Staff Report
City of Richmond, Virginia

Commission of Architectural Review

COA-103042-2021	Conceptual Review	Meeting Date: 12/21/2021
Applicant/Petitioner	Josh Bosler, Center Creek Homes	
Project Description	Construct two new attached, 3- story single family residences.	
Project Location		
Address: 413-415 N. Arthur Ashe Blvd.		
Historic District: Boulevard		
High-Level Details: <ul style="list-style-type: none"> • The applicant proposes to construct 2 new attached single family dwellings • The proposed new construction is 3 stories tall with a recessed third story, roof top terrace, and a flat roof form. • The building will be 4 bays; the two, projecting outer bays having vertically aligned groups of three windows. • Cladding will consist of brick and horizontal siding. 		
Staff Contact	Eva Campbell, eva.campbell@RVA.gov , 804-646-7550	
Previous Reviews	None	
Staff Recommendations	<ul style="list-style-type: none"> • Staff recommends that the building reflect a form that is more in-keeping with existing single-family residences in the district. • Staff recommends that the new construction have a pitched or mansard roof form that is visible from the street. • Applicant consider t

Figure 4. Context drawing of new construction

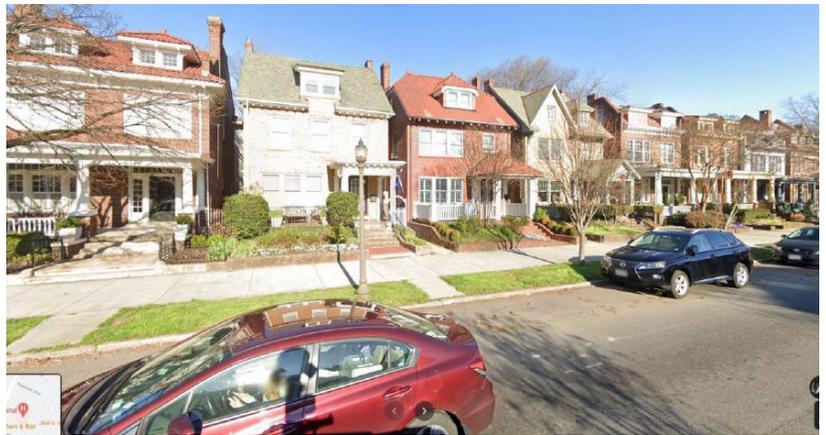
will be minimally visible from the street and alley.
	<i>The cornice height should be compatible with that of adjacent historic buildings.</i>	The renderings in the application demonstrate that the second story cornice line is compatible in height with the adjacent building's cornice lines.
Materials and Colors, pg. 47, #2-4	<i>Materials used in new residential construction should be visually compatible with original materials used throughout the district</i>	The new construction will utilize brick and horizontal lap siding. From the conceptual rendering provided with the application, it is unclear whether or not the projecting bays on the front façade will be clad in horizontal lap siding or solid paneling. Staff notes that there are not examples of horizontal lap siding on the front façade of buildings within the district, and <u>recommends that the front façade utilize brick, or brick and solid paneling.</u> Stucco, a common material found in the district, would also be an appropriate cladding for the front façade.
